SEWAGE DISPOSAL SYSTEM

HOWARD COUNTY HEALTH DEPARTMENT
BUREAU OF ENVIRONMENTAL HEALTH

SUBDIVISION Warfield Estates III LOT NUMBER 7 ADDRESS 3428 Shady Lane

LDE, INC.		
9250 Rumsey Road, Suite 108, Columbia, MD. 21045 (410) 715-1070 (301) 596-3424 (410) 715-9540 (Fax)		
Designed: BDB	PERCOLATION CERTIFICATION PLAT WARFIELD ESTATES SECTION 3	Scale: 1"= 50'
Drawn: STB	BLOCK B LOT 7 4th ELECTION DISTRICT HOWARD COUNTY, MD.	Drawing: 1 of 1
Checked: BDB		Job No. 99-070
Date: 12-99	Builder: BETHANY HOMES, INC. 14670 Rothgeb Drive Suite 201 Rockville, MD 20850 301-294-1964	File No.

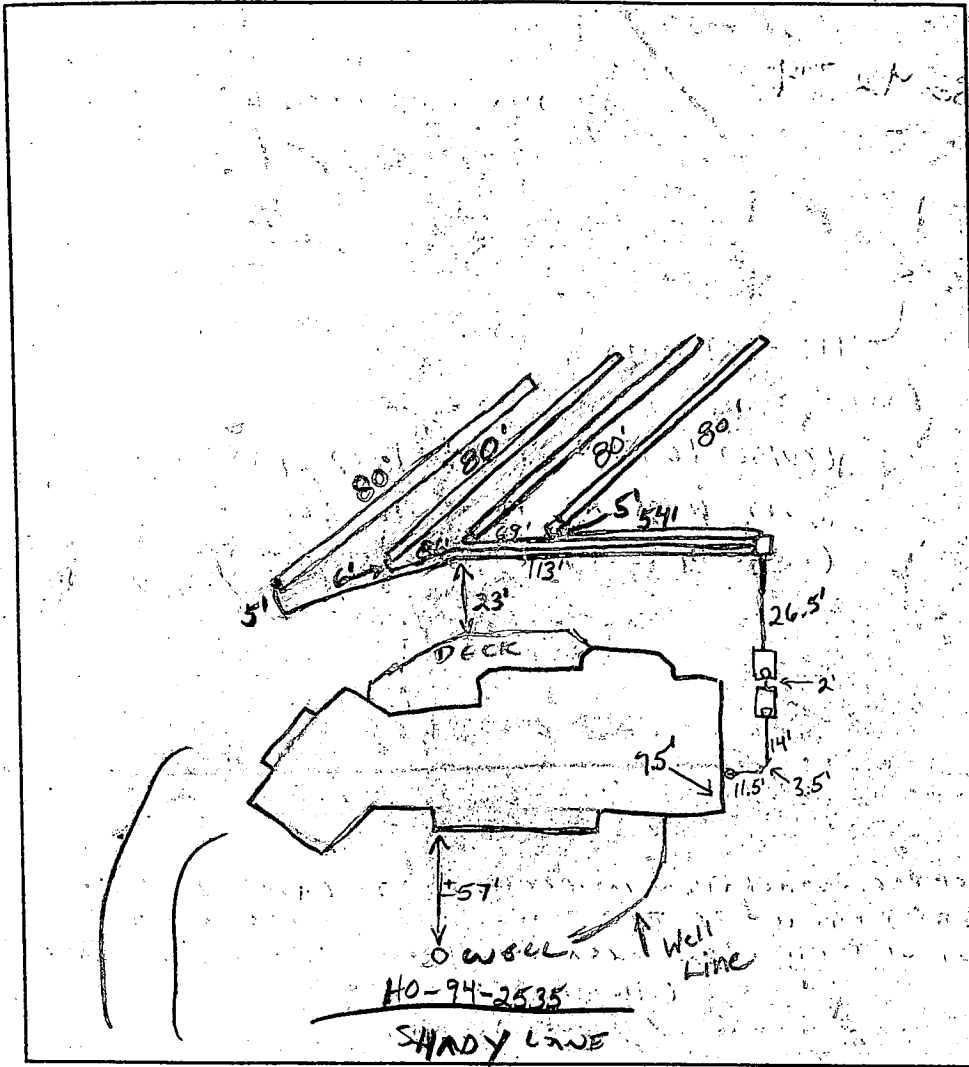
PRE-CONSTRUCTION INSPECTION: SEE REVISED LOCATION SPECIFICATIONS ON OTHER SIDE. 7/11/00 CW

INSPECTION COMMENTS: 7/18/00 House connection made. O.K. to cover tanks. To install 4-80' trenches with 6' edge to edge spacing. Trenches are to start at very beginning of easement in driveway area and are to run towards rear lot line (BB) 7/19/00 WPI ok. First trench started. Trenches not to be deeper than 5.0' (BB) First 2 trenches done. O.K. to cover. Third trench dug. Six foot spacing between trenches. To leave beginning and end of last 2 trenches open. (BB)

7/21/00 Finished last two trenches. System satisfactory. (BB)

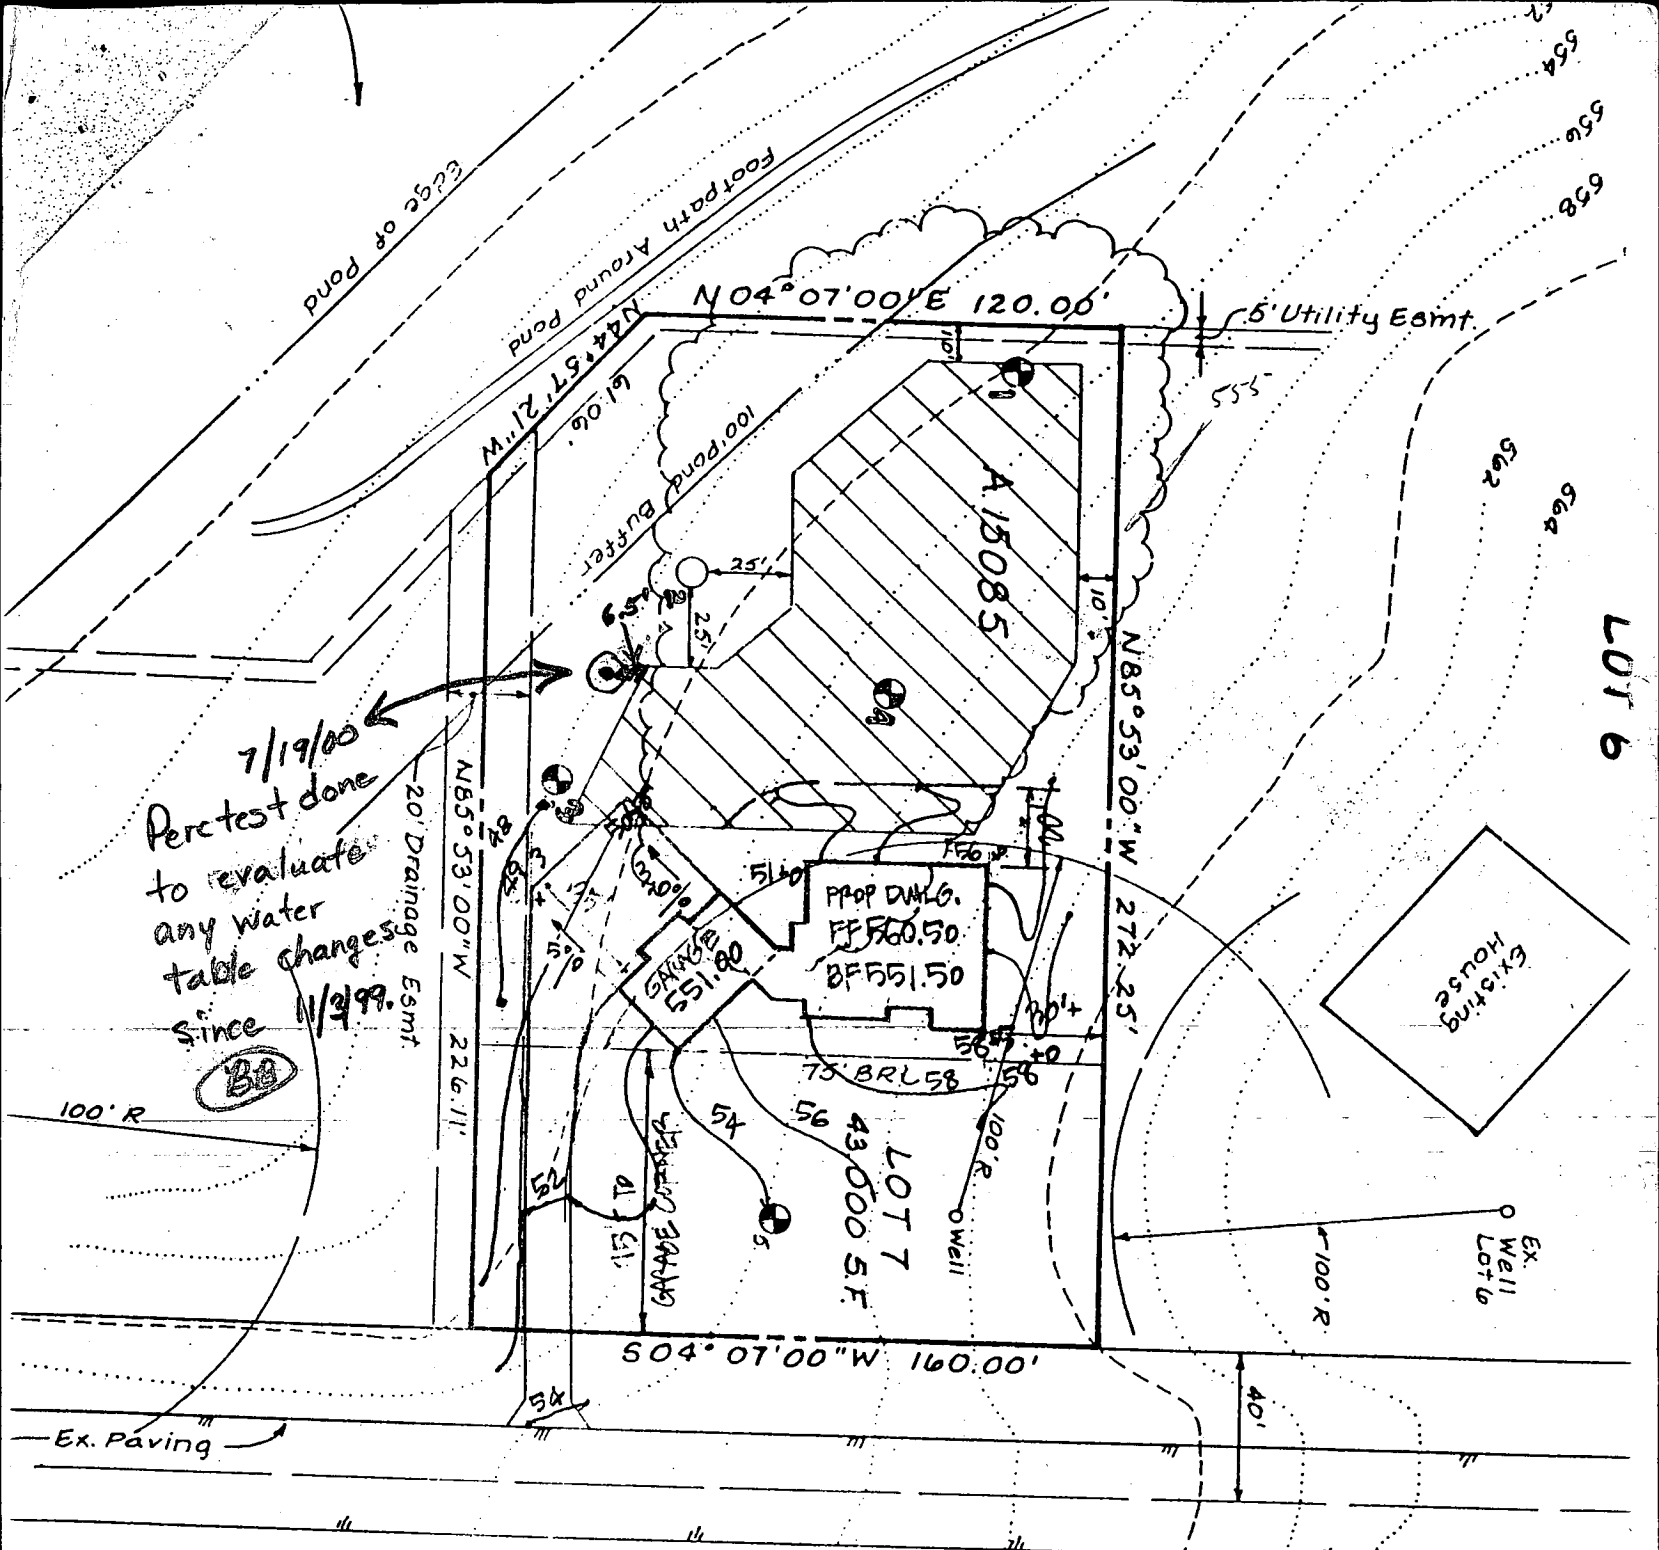
7/19/00
 Per test done
 to evaluate
 any water
 table changes
 since 11/2/99.

3.8'	clay loam
	Sa loam
8.0-8.5'	Moist, Mottling
9.5'	Caving
11'	Water

Results similar to testing done by Craig Williams. Treatment area very close to unacceptable limits. Trenches cannot be installed any deeper than 5.0'. BB
 are unacceptable.

49317

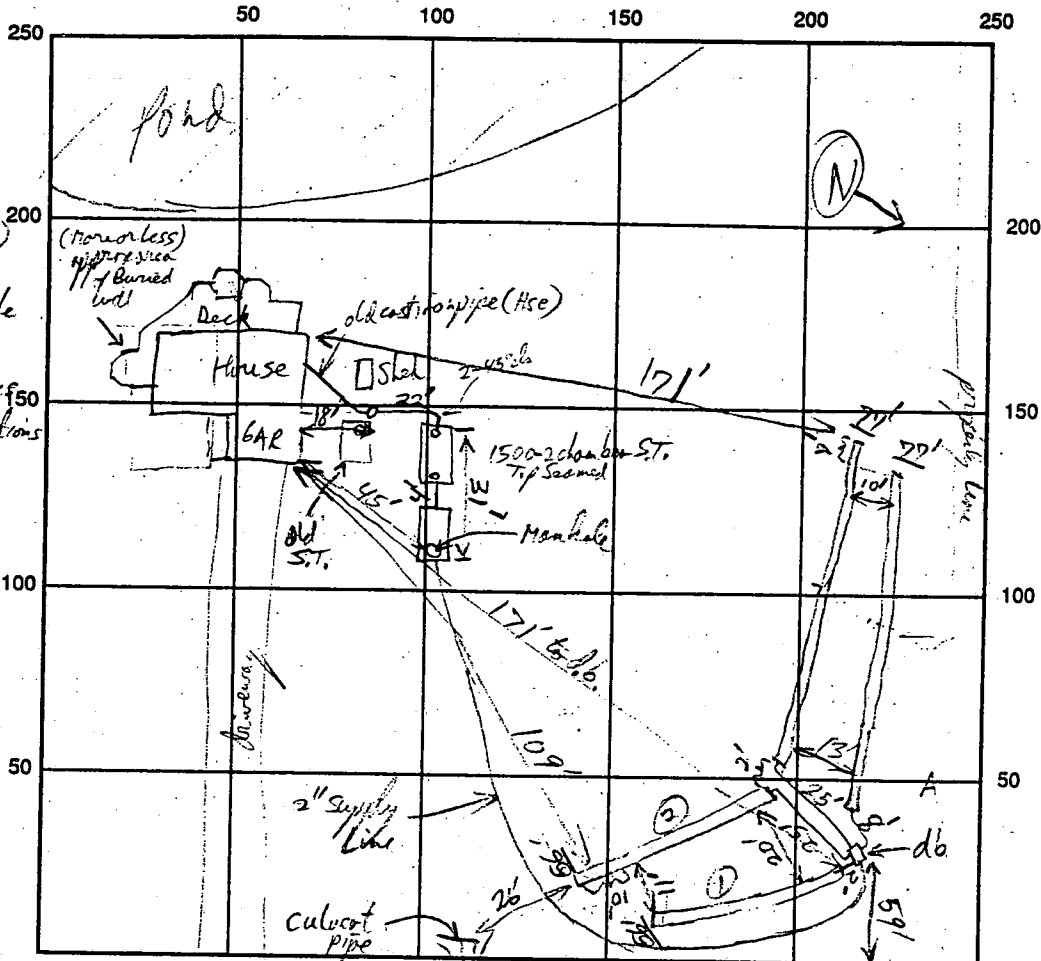
Excavation @
 pump chamber
 bottom soil is
 a coarse sand, tan
 with coarse
 small distinct (cl) of
 iron concretions.
 Indicates some
 seasonal water table
 problems @ 6-7 ft
 below ground surface
 at S.T. + P.C. locations
 near house.

REMARKS: Trench #1 entire length Bottom just contacting into sand. Loam Soil, ~75% of trench has 1-1 1/2 ft
effective sidewall of this soil. Material Hse connection is connected from old S.T. Pump Chamber +
New Septic Tank & etc. OK to lower trench #1 R/R 8/11/93 used 2" supply pipe (Flanell
Pump Chamber OK. All trenches contact into comp. sand. OK to lower R/R 8/12/93
(120 gal base)

CONCEPT GRADING

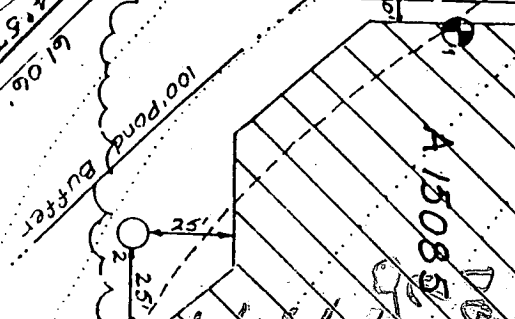
- SHOW 8-40' TANKS
- RUNNING BACK TOWARD HOUSE,
- INTUITION SHOULD SHOW ROOM
- FUN 1 MORE GAUITY SERVICE
- AT 1 MORE PUMPED SYSTEM,
